Re: MODIFICATION - Risk Based Site Cleanup and Disposal Plan
Thomas Prince School
170 Sterling Road
Princeton, MA 01541

**MODIFICATION OF:
RISK BASED SITE CLEANUP
AND DISPOSAL PLAN**

**THOMAS PRINCE SCHOOL
TOWN OF PRINCETON, MA**

Figure 3: Typical Windows: 100-Wing Classrooms, Exterior View: Structural Elements.

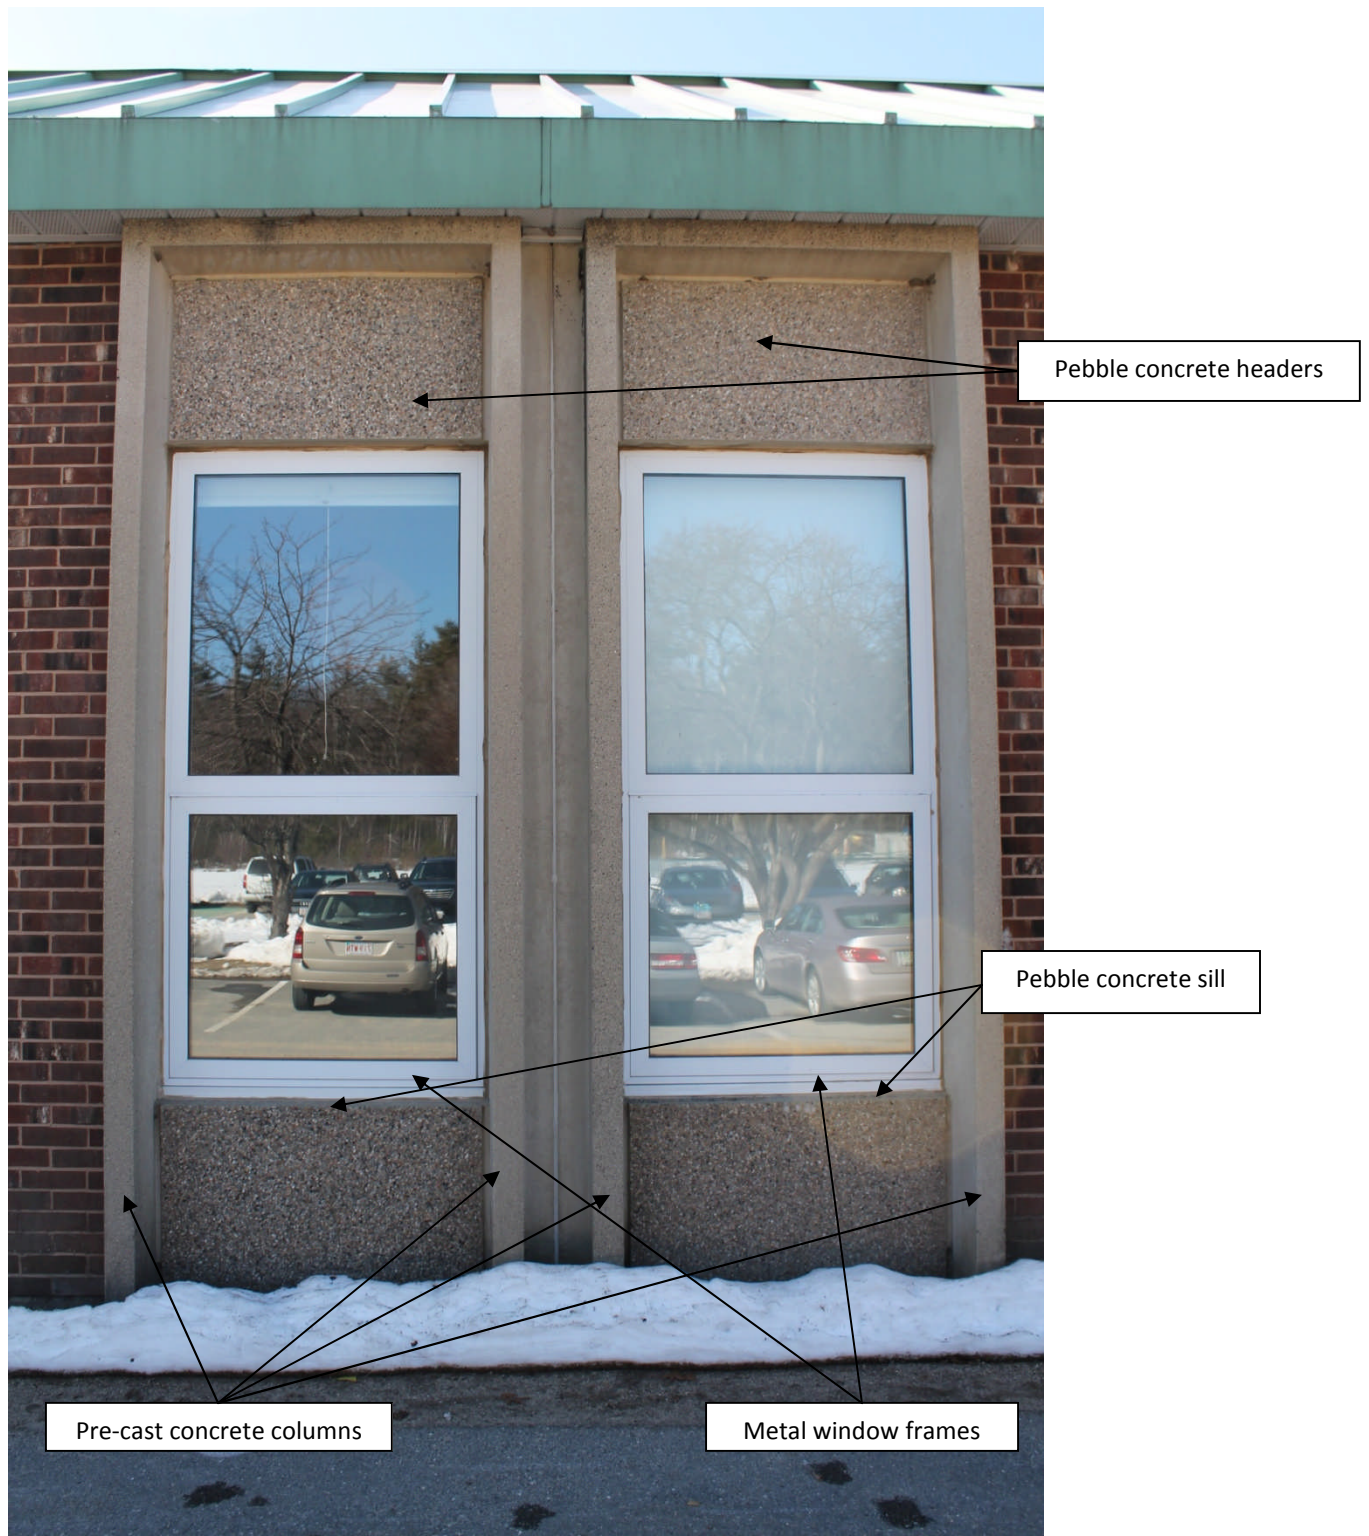
The concrete window column structures include decorative pebbled concrete panels above and below the windows (**Figure 3**). The pebbled concrete parts which form sills beneath the window casing were sampled at classrooms 102 and 108 (seven samples, including one duplicate, at six locations). Samples were collected from the horizontal, sill-like portion, of these structures beneath the windows. No concentrations of PCB's in excess of 1 mg/Kg were detected in the seven samples of material collected from these structures. Concentrations of PCB's ranging from 0.16 mg/Kg to 0.086 mg/Kg were detected at three of the six locations sampled. No detectable concentrations of PCB's (at laboratory reporting limits of 0.0673 mg/kg or less) were present at three locations.

Vertical joints between the concrete window columns that separate the windows and the vertical joints at the outer edges of the pre-cast concrete columns adjacent to the brick façade of the building contain caulking contaminated with PCB's. Caulking present in these joints will be removed by manual means until no visible caulking material remains. The cleared joints will then be cleaned using a HEPA vacuum followed by organic solvent wash.

- **Exterior Porous Surfaces:** The exterior adjacent building materials (the pre-cast concrete columns on either side of a window, and the masonry brick present on the outer sides of the outer-most concrete columns) will be coated with two layers of an epoxy resin. Epoxy encapsulation will be extended to a minimum of 3 inches from the joint onto the surface of the adjacent pre-cast concrete column and a minimum of 4 inches from the joint onto the adjacent brick facing surface. The surface of the pre-cast concrete column in between the windows will be fully coated with epoxy.

Figure 5: Typical Exterior Vent Structure: 100 Wing Classrooms.

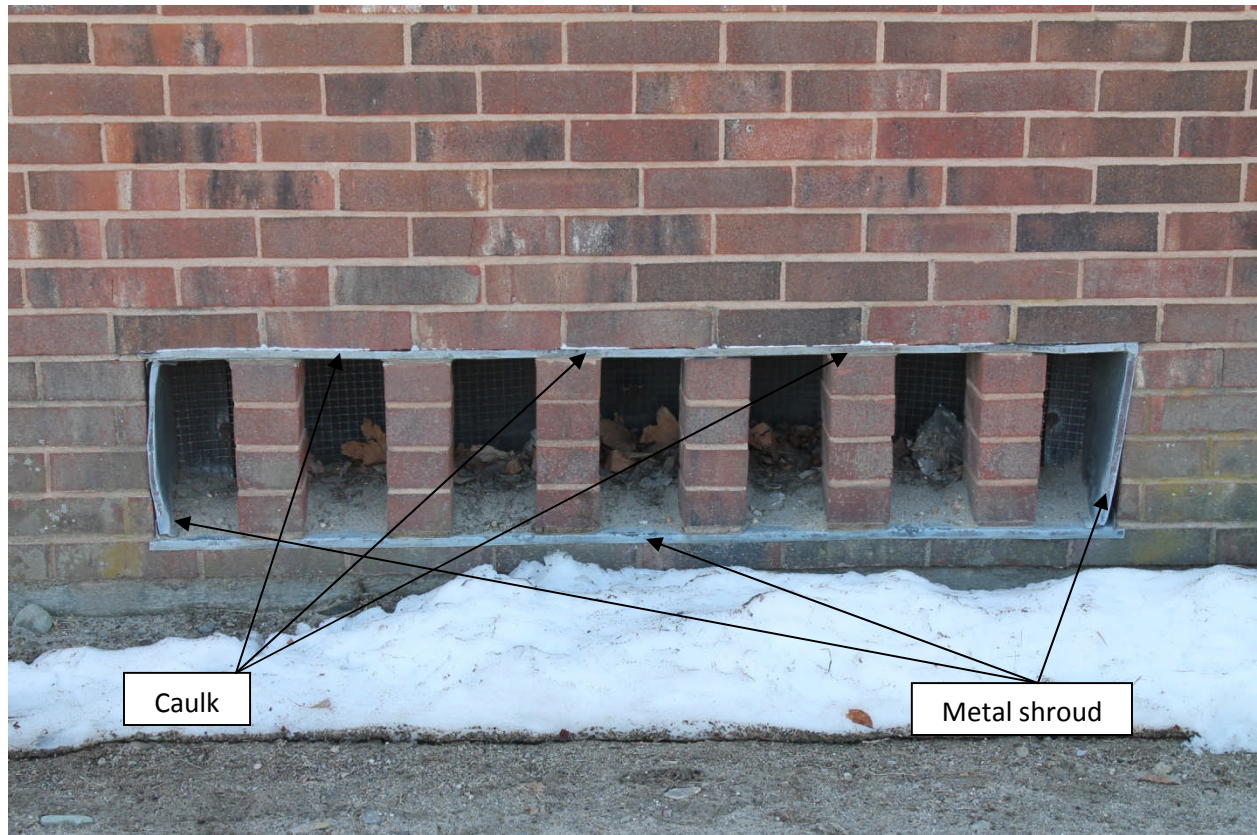
- Exterior caulking around the air intake vents for unit ventilators for Rooms 100, 102, 104, 108, and 110 will be removed (caulking around the vents for Room 106 has been previously removed). The building surface in the vicinity of the caulk removal area will be cleaned with a HEPA vacuum, followed by a wash with organic solvent. The building surface materials around the vent will be encapsulated with two layers of an epoxy coating to a minimum distance of eight inches from the edge of the vent).
